33167
Landfill

MEMORANDUM

TO : Mark Witherspoon, Chief, Solid Waste Division
FROM : Tony Morris, Geologist Solid Waste Division YM
DATE : 5-APR-1990
SUBJECT : Groundwater monitoring at the Sunray sanitation landfills (Permit No. 162-SR1 and 123-SR1)

LEGEND

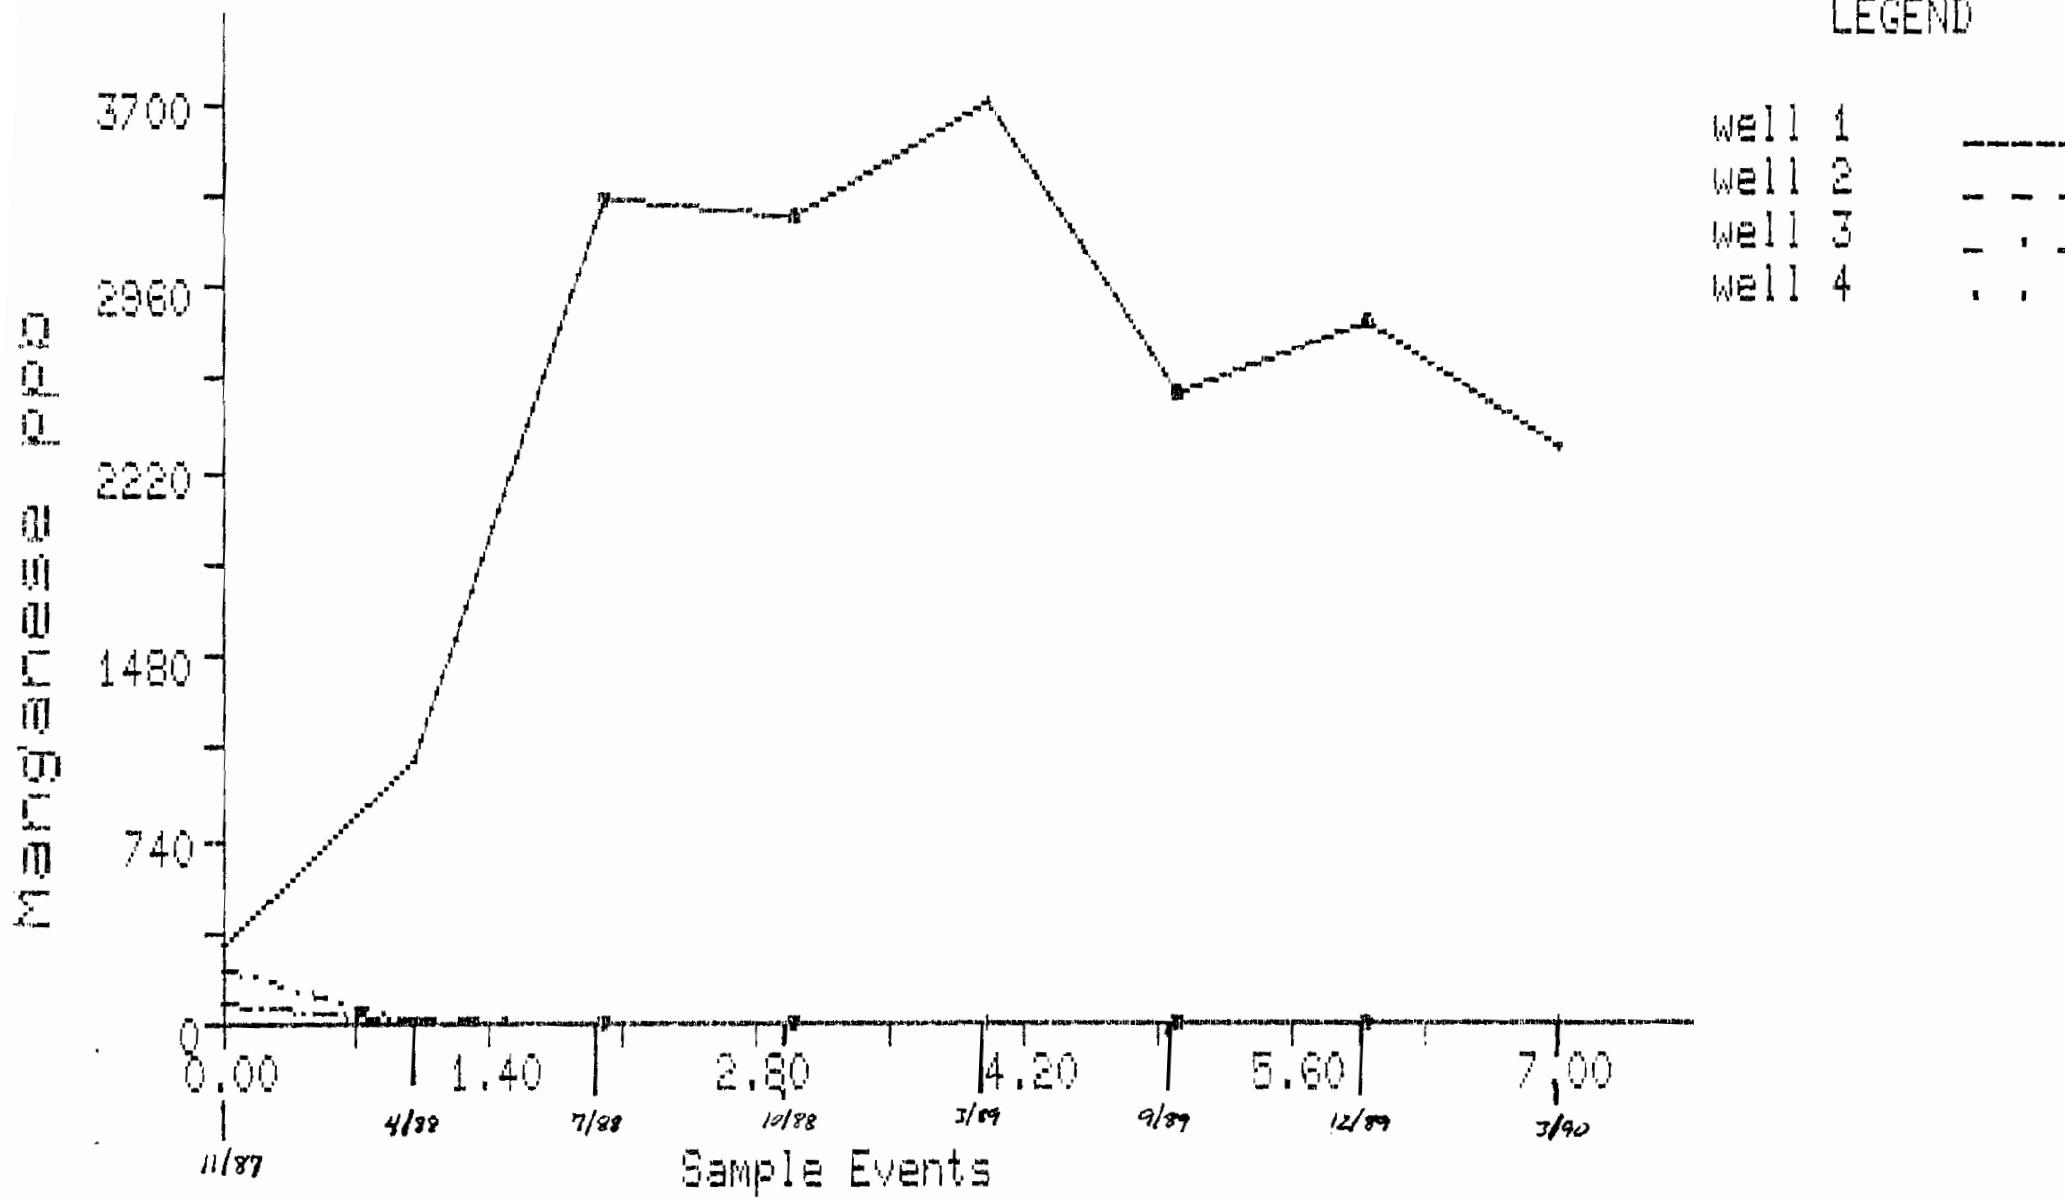
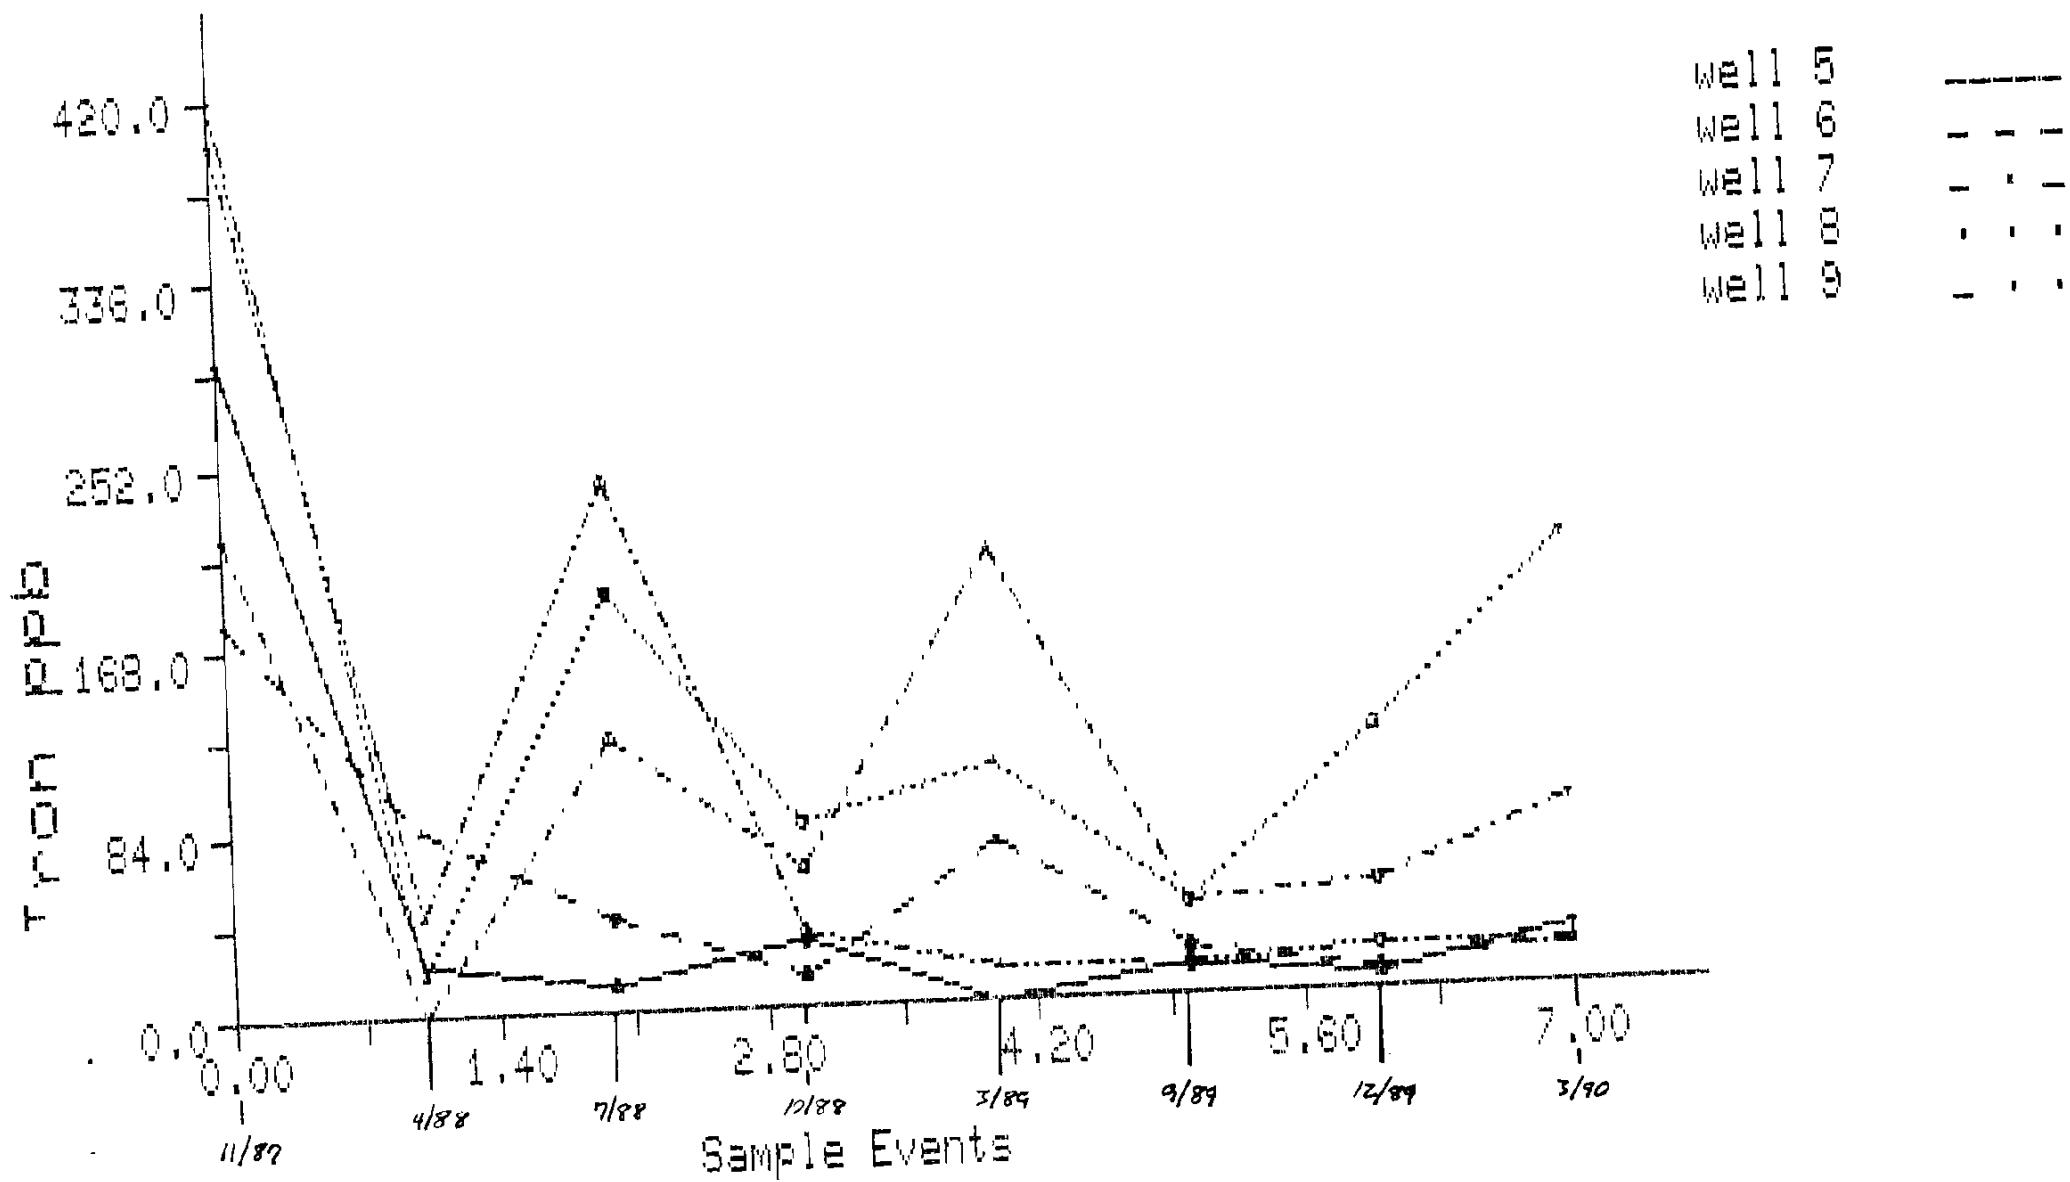
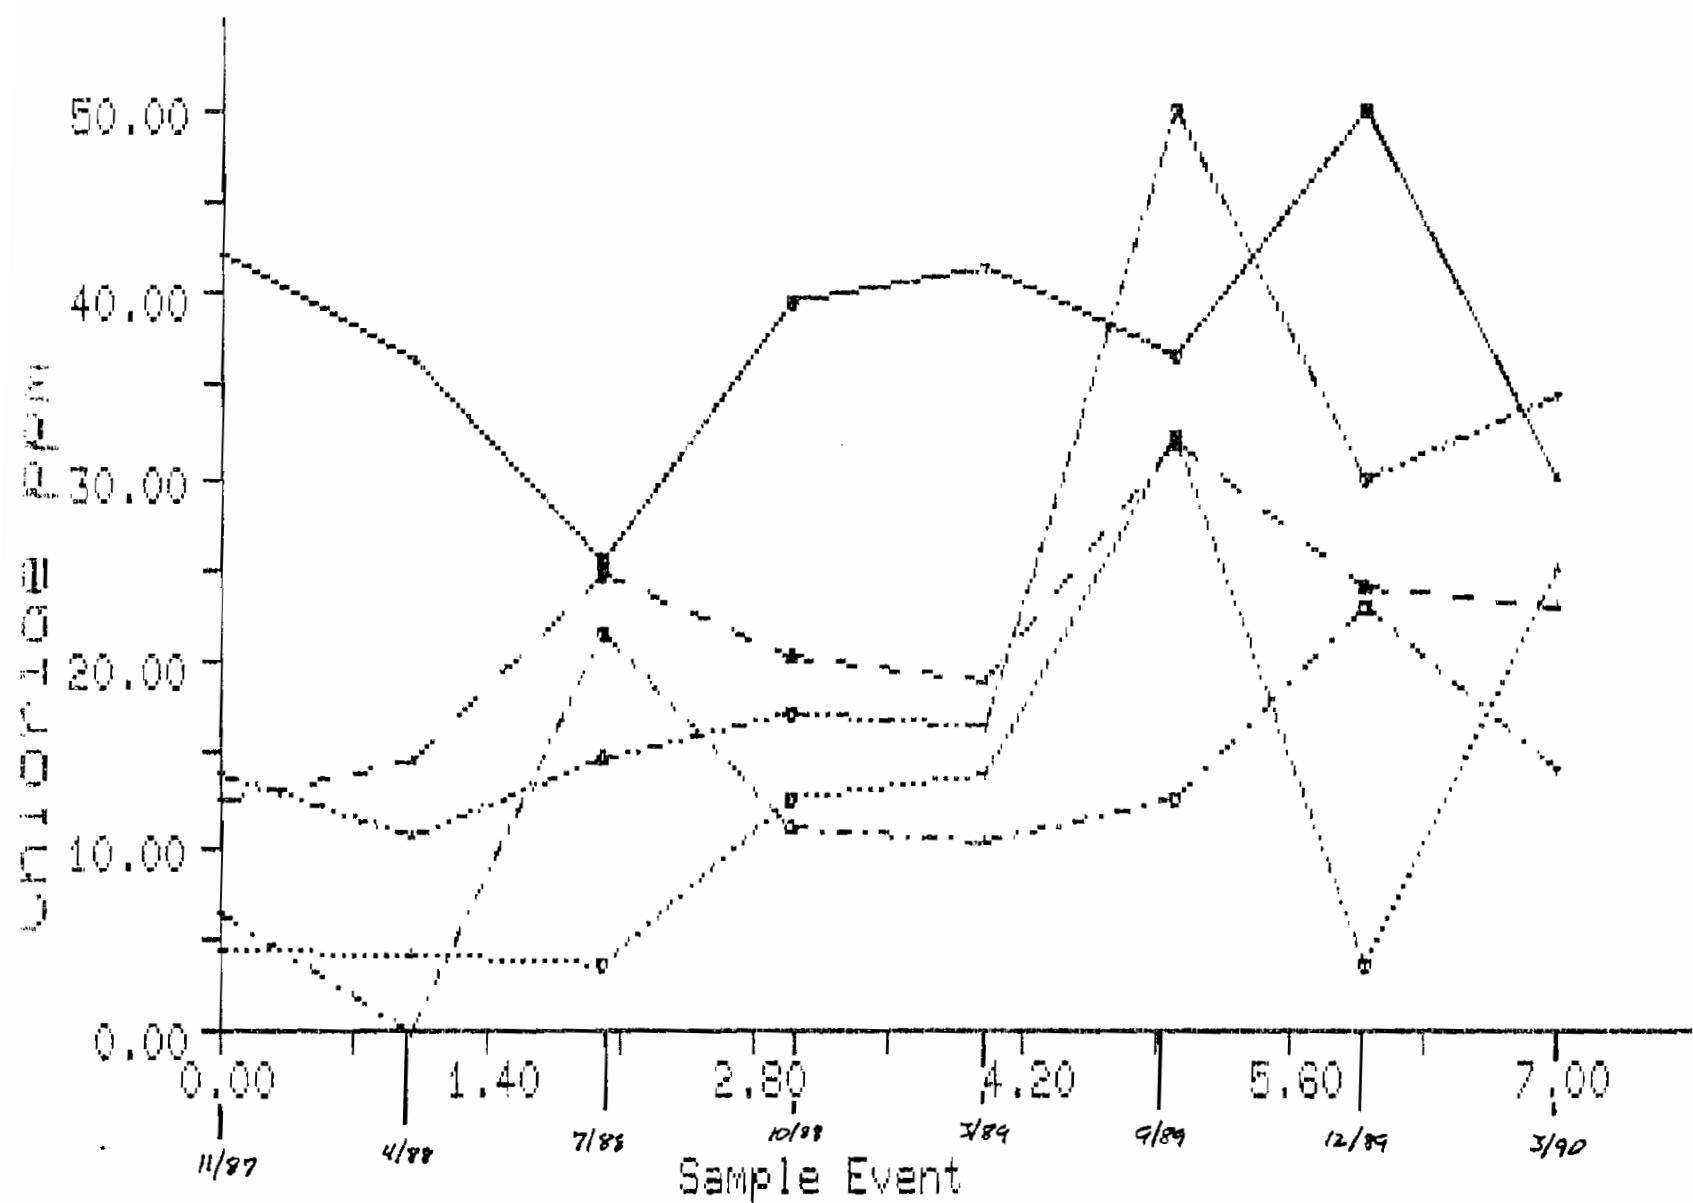
The data submitted thus far indicate the water quality between wells is much greater for each sampling event than would be expected for wells screened in the same hydrologic unit.

It is obvious from the data that several parameters exceed the National Secondary Drinking Water Standards in certain wells. Also, the last round of sampling at the facility indicated a positive detection of Methyl Ethyl Ketone in wells #7 and #9. This man made compound does not occur naturally in groundwater and is a constituent of a R.C.R.A. listed hazardous waste which was received by the facility on a regular basis prior to a 1986 legal action by the Department. Therefore, the positive detection can only be due to leakage from the landfill or laboratory error.

It would be appropriate at this time to require the facility to expand the list of parameters analysed for in the monitor well system. The list should include volatile and semi volatile compounds. The company should evaluate their sampling and analysis plan to insure the integrity of the reported values. It may be appropriate for the Solid Waste Division staff to split samples with the company at the next sampling event.
